ADDENDUM NO. 1

ADA PARKING LOT IMPROVEMENTS PROJECT

SPEC NO. 2026.8518-21

October 1, 2025

(See illustration snips from Sheet 2 of **the Bob Kildee Park Pavement, Grading and, Striping Plan** on Pg. 3 of this Addendum) use Bid Alt Schedule form on page 4 of this Addendum.

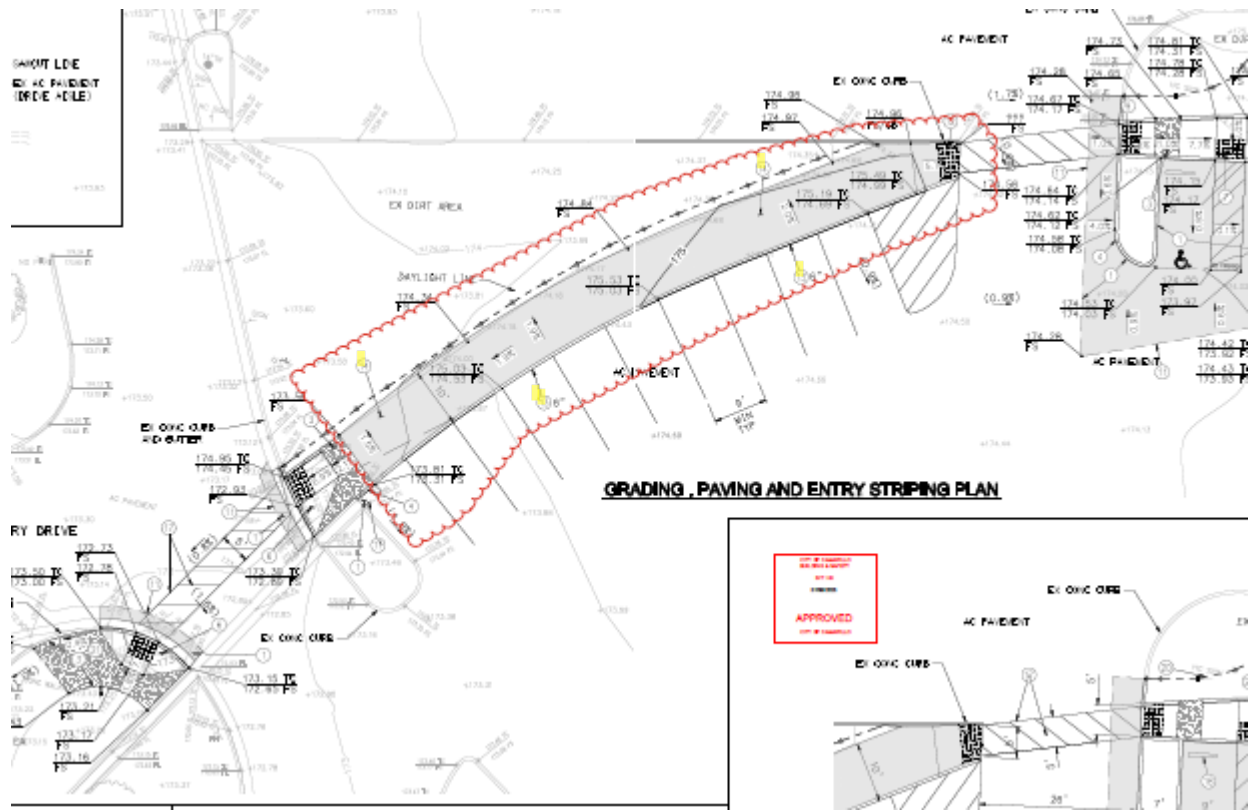
This addendum serves to incorporate an **Add Alternative Bid** for a concrete curb and walkway in lieu of AC berm and walkway. Include any associated costs for additional demolition work necessary for this alternate bid.

The following identifies the area and scope for the Add Alternative Bid (See highlighted construction notes and call-outs):

13. CONSTRUCT 6" CURB PER CAMARILLO STD PLATE E-4.1 (REV D), TYPE A-1

14. DEMO EXISTING AC WALK AND CONSTRUCT 4" CONCRETE WALK OVER NATIVE SOIL TO 95% RELATIVE COMPACTION AND SPPWC STD 112-2
